PROTECTION CONTROLS INC.  
SKOKIE, ILLINOIS

CONTACT CONFIGURATION FOR V2N4T911-UL  
OFF-RUN-IGNITION SWITCH AS USED ON  
UNIFIED CONTROL PANEL NO. 62021

JOB NO.	DRAWN BY	DATE:	DRAWING NO.
	R.N.	9-21-01	X-375

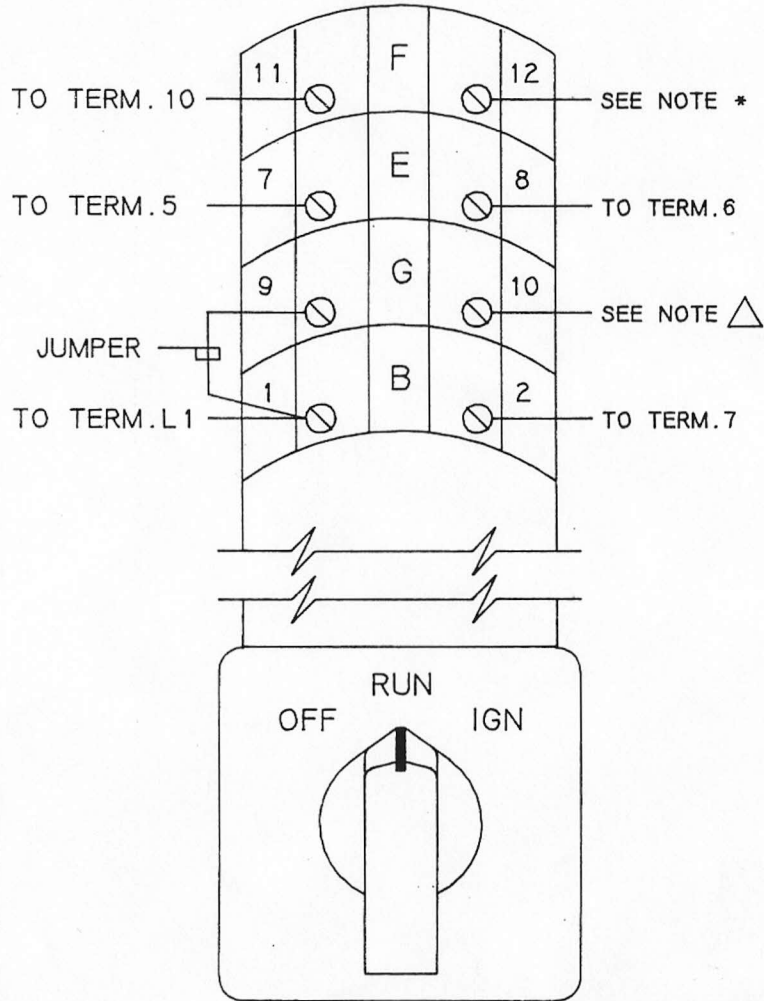
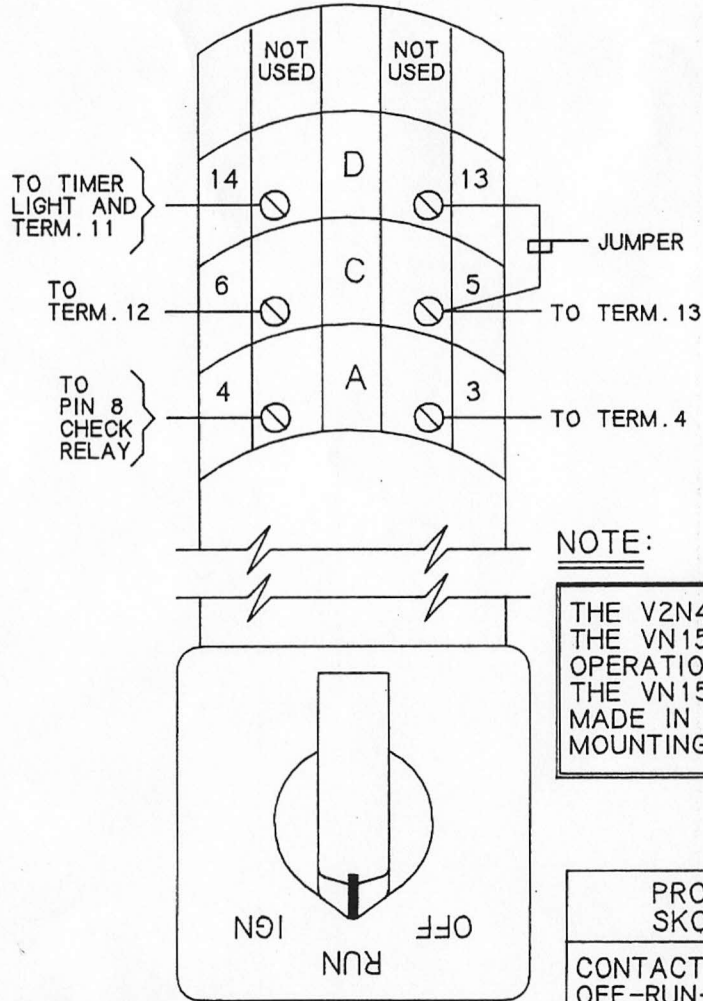
THE V2N4T911-UL SWITCH SUPERSEDES  
THE VN154T911-UL AND IS IDENTICAL IN  
OPERATION. IF IT IS USED TO REPLACE  
THE VN154T911-UL, A NOTCH MUST BE  
MADE IN THE TOP OF THE EXISTING  
MOUNTING HOLE TO PREVENT ROTATION.
